UNITED STATES PATENT AND TRADEMARK OFFICE

APPLICATION NO.	FILING DATE	FIRST NAMED INVENTOR	ATTORNEY DOCKET NO.	CONFIRMATION NO.
10/646,643	08/22/2003	George William Dailey	2003P07970 US	9785

Office Action Summary	Application No. 10/646,643	Applicant(s) DAILEY, GEORGE WILLIAM	
	Examiner Timothy M. Ayres	Art Unit 3637

DETAILED ACTION

King '090 Fig. 1

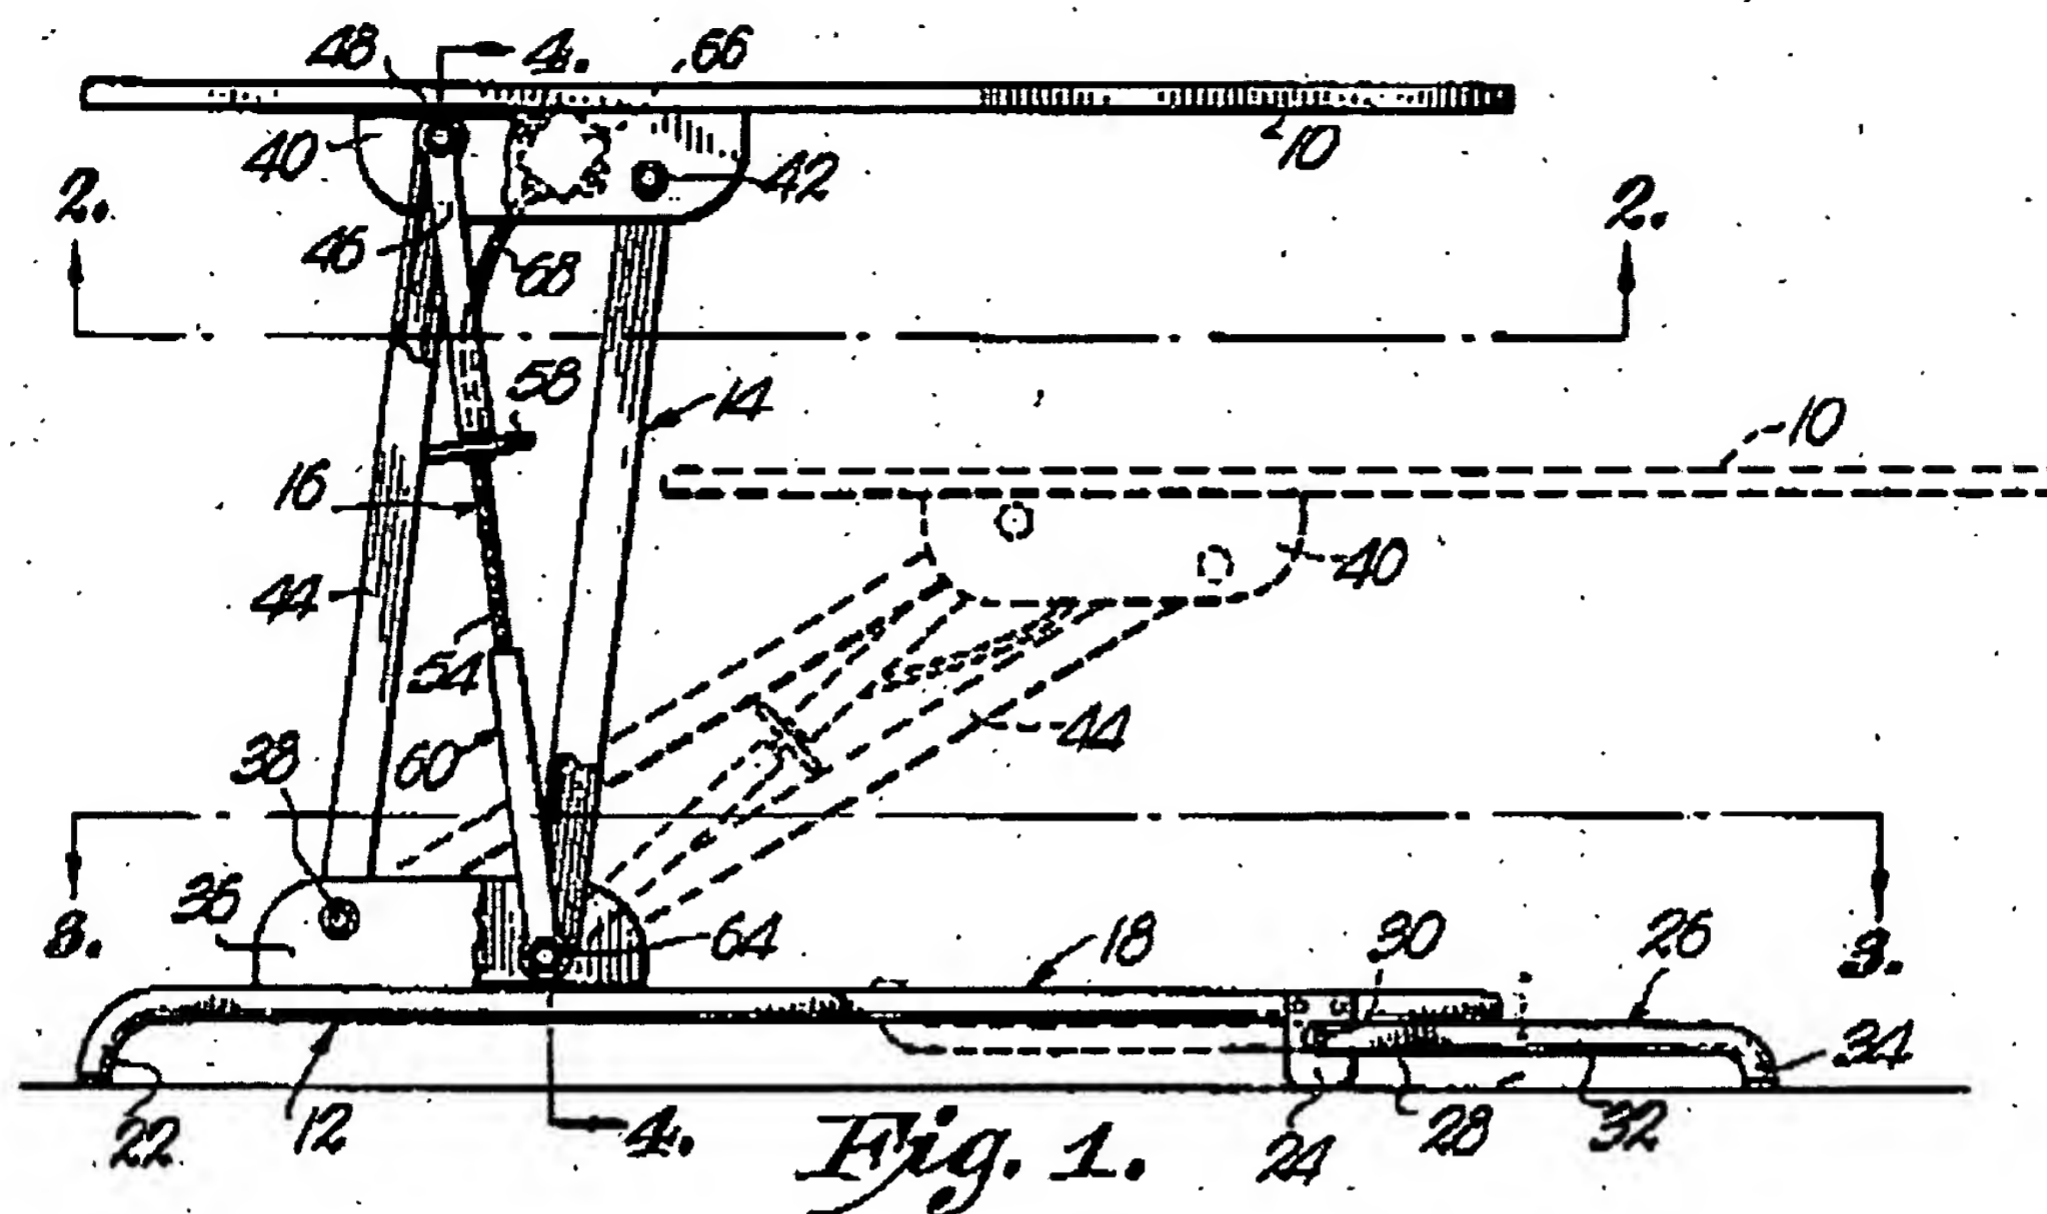
8. Claims 1-4 and 8 are rejected under 35 U.S.C. 102(b) as being clearly anticipated by U.S. Patent 3,288,090 to King. King '090 discloses an elongated

planar member (10) that has a top and bottom side and inherently can support a patient. A support assembly (12) includes a base (18) that defines the base plane and a pedestal (36) disposed on the base (18). A plurality of elongated connecting arms (14), with a first end defined by pins (42) and a second end defined by pins (38). The first end of the elongated members (14) is pivotally attached through pins (42) to the bottom of the planar member (10) through flange (40). The second end of the elongated members (14) is pivotally attached through pins (38) to the base pedestal (36). The planar member (10) moves from a first position to a second position as shown in figure 1 with the elongated members (14) traveling through an axis that is orthogonal to the base.

9. The means for moving the planar member from the first position to the second position is a motor assembly (66, 68) with a screw member (54), which connects to the pins (38,42) and the connecting arms. The plane of the first position and the plane of the second position are parallel to each other and the base plane as shown in figure 1. The plurality of elongated members (14) is arranged in a four bar linkage.
